Technical Note 002

Response to tree team consultation comments

Application reference DC/23/0406 is before Horsham District Council for determination.

Section A-A

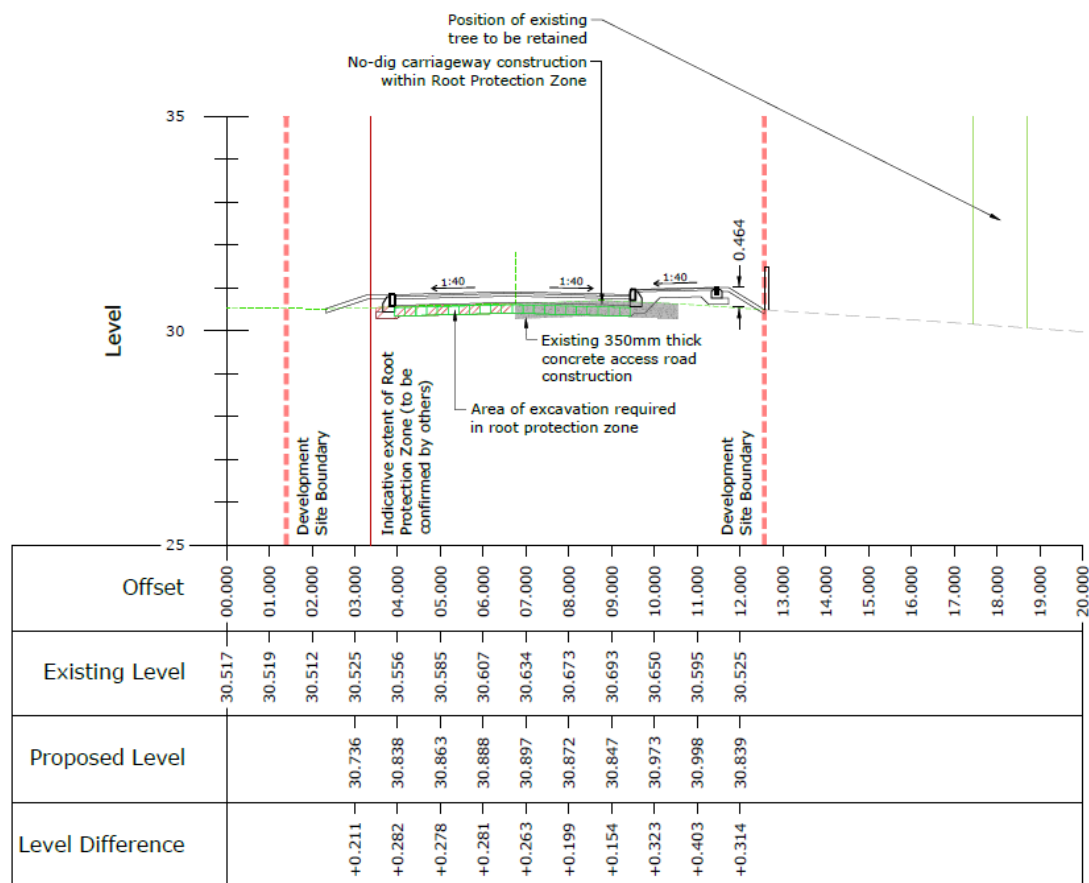
1. The specific construction details for the proposed access road
2. The installation of services along the proposed access road

The specific construction details are shown on the *Proposed Site Access Typical Sections* drawing reference 2109010-SK-01 Rev C at Appendix 2 of the submitted method statement.

An extract of Section A-A from that drawing is shown below. It can be seen from the section that the proposed access will be of no-dig construction and make use of the void created by removal of the existing, non-porous concrete road. The adjoining pathway, closest the tree, will also be of no-dig construction and raised above existing soil levels. The specific construction details are therefore already set out and are appropriate for the situation. They accord with the guidance in *BS5837:2012: Trees in relation to design, demolition and construction – Recommendations*.

Adherence to this specific method of construction can be achieved through the planning consent.
